## ADDENDUM NO. 1

**Sault Ste. Marie Public Schools  
Middle School Structural Roof  
Repairs and Roof Replacement  
Sault Ste. Marie, Michigan**

ADDENDUM NO. 1 is issued April 11, 2025, to clarify, modify, and/or change the original plans and specifications issued by UP Engineers and Architects. This ADDENDUM NO. 1 is hereby made part of the Contract Documents for the contract noted below.

A1 PROPOSED ROOF FRAMING PLAN IN COLLAPSED ROOM  
1/4" = 1'-0"

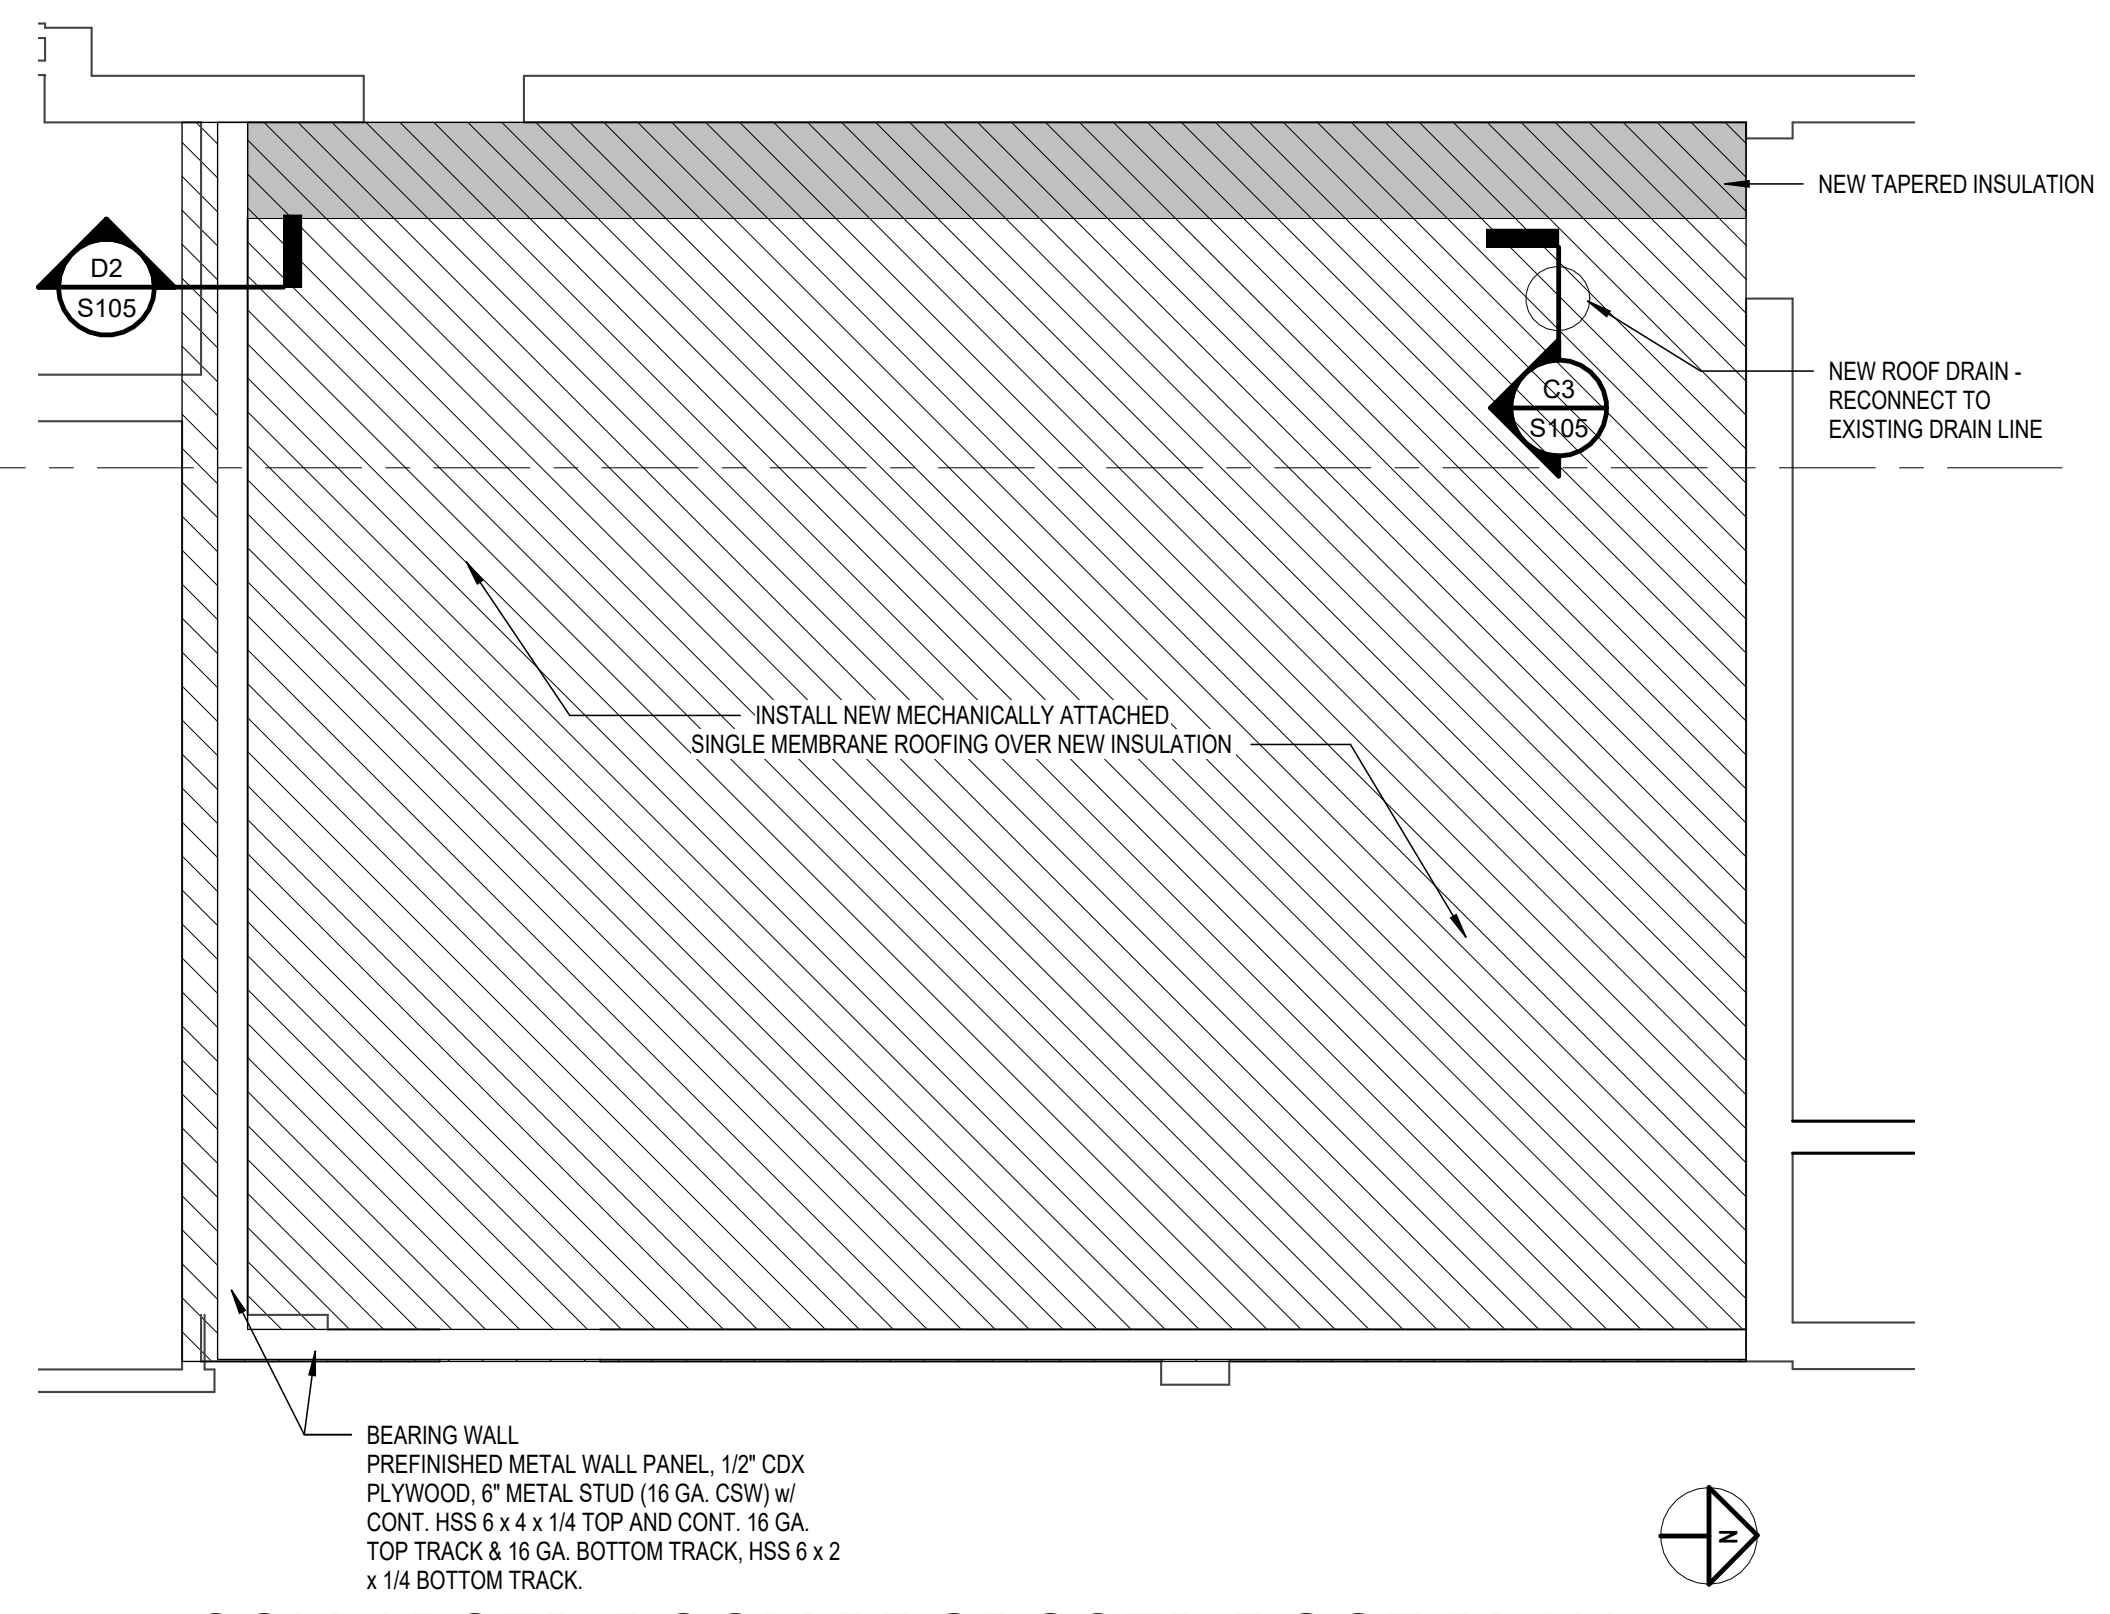
5. See **attached** revised structural details.
  - a. Metal panel at vertical roof extensions.
  - b. Treated plywood on parapet walls.
  - c. Cuts through new beams.
  - d. Denote bearing walls.

- NOTES:
- RAISE ALL VENTS, MECHANICAL EQUIPMENT, ROOF DRAINS, ETC. UP TO NEW ROOF ELEVATION.
  - FILL VOID BETWEEN PROPOSED NEW ROOF AND EXISTING ROOF COMPLETELY WITH BLOWN-IN FIBERGLASS INSULATION.
  - METAL WALL PANELS TO BE MINIMUM 24 GA. THICK PAINTED STEEL; 5+ YEAR WARRANTY; MANUFACTURER: METL SPAN, PROFILE: CS-260, COLOR: "REGAL BLUE".
